DEFENSE NUCLEAR FACILITIES SAFETY BOARD

September 24, 2020

POTENTIAL ENERGETIC CHEMICAL REACTION EVENTS INVOLVING TRANSURANIC WASTE AT LOS ALAMOS NATIONAL LABORATORY

Defense Nuclear Facilities Safety Board Technical Report

Figure 2. Area G Dome 49

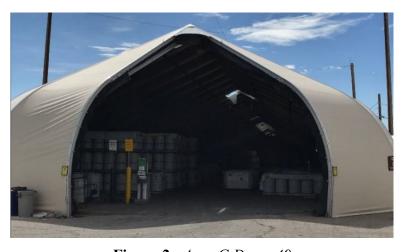
Area G does not have multiple layers of protection to prevent or mitigate a chemical reaction event. Area G stores transuranic waste in domes that typically consist of an aluminum frame with a fabric shell (Figure 2). While several storage domes have general service fire suppression capabilities, the Area G safety basis allows transuranic waste to be stored in domes that lack a fire suppression system. Area G personnel perform weekly radioactive contamination monitoring; however, the storage domes do not have continuous air monitors. Further, Area G personnel recently rolled back the Area G radiological buffer area, and associated radiological work permits no longer require workers to perform a radiological survey prior to exiting Area G.

Although preferred, the Board's staff team does not believe that LANL needs to store all transuranic waste containers in facilities with confinement ventilation or fire suppression systems. Rather, LANL could preferentially store higher-risk waste containers (e.g., poorly characterized waste, waste with high quantities of MAR, waste that has not undergone a chemical compatibility evaluation, or waste with incompatible chemical constituents) in locations with more robust control sets. Further, other types of controls, such as overpack containers, lid restraints, blast shields, and detection capabilities could be used to mitigate the consequences of such an event. At a minimum, LANL should evaluate the existing control sets at all transuranic waste storage and generation facilities to determine if the facilities have adequate controls in place to protect workers and the public from energetic chemical reaction events that may occur in transuranic waste containers.
